The amendment revises the Technical Specifications in respect to Power Distribution Control, Allowable Control Rod Misalignment and Control Rod Position Indication Systems.

KEWAUNEE NUCLEAR PLANT

Amendment No. 41
License No. DPR-43

AMENDMENT NO. 41 TO FACILITY OPERATING LICENSE NO. DPR-43

Figure TS 3.10-6

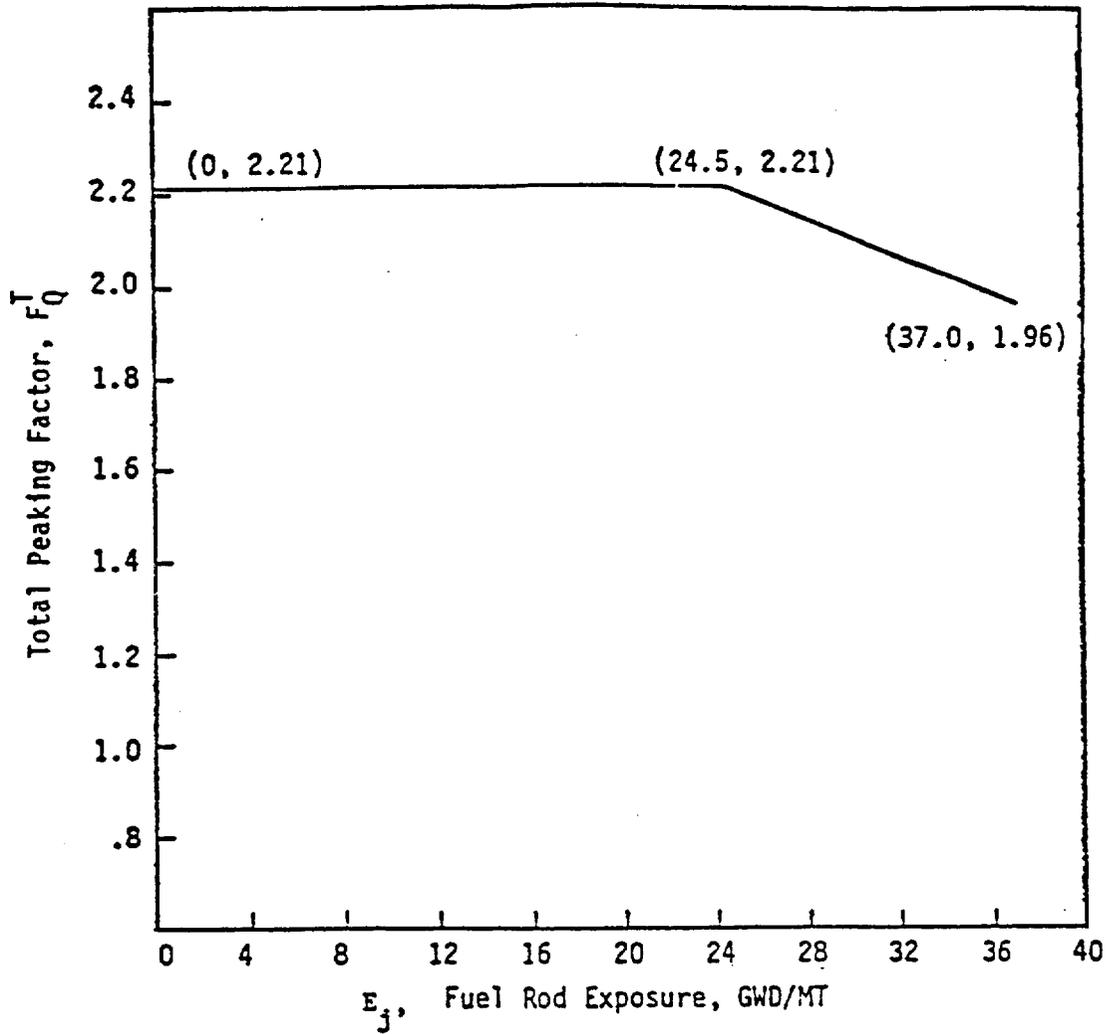
$$F_Q^N(Z) \times 1.03 \times 1.05 \leq F_Q^T(E_j)/P \times K(Z) \text{ for } P \geq .5$$

F_Q^T (Ej) is the function given in Figure TS 3.10-6

The $F_Q^N(Z)$ limits of specification 3.10.b.1.A include consideration of enhanced fission gas release at high burnup, off-gassing (release of absorbed gases), and other effects in fuel supplied by Exxon Nuclear Company; this results in an additional penalty in the form of the function $F_Q^T(E_j)$, as shown in Figure TS 3.10-6, which is applied to Exxon fuel. References 7 and 8 discuss these phenomena.

Figure 3.10-7
Amendment No. 41

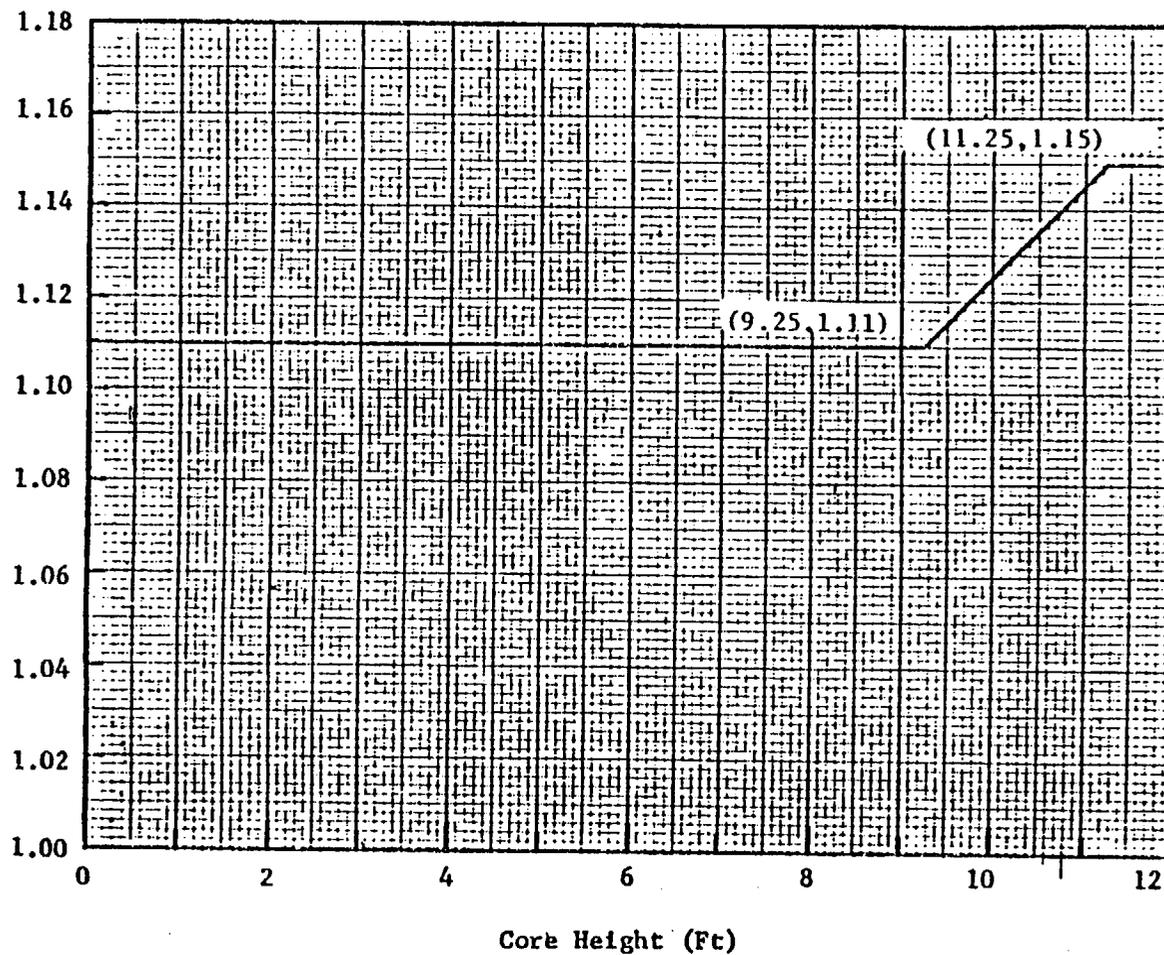
- A. Westinghouse Electric Corporation Fuel
$$F_Q^{EQ}(Z) \times 1.03 \times 1.05 \times V(Z) \leq (2.22/P) \times K(Z)$$
 - B. Exxon Nuclear Company Fuel
$$F_Q^{EQ}(Z) \times 1.03 \times 1.05 \times V(Z) \leq F_Q^T(Ej)/P \times K(Z)$$

V(Z) is defined in Figure TS 3.10.-7.
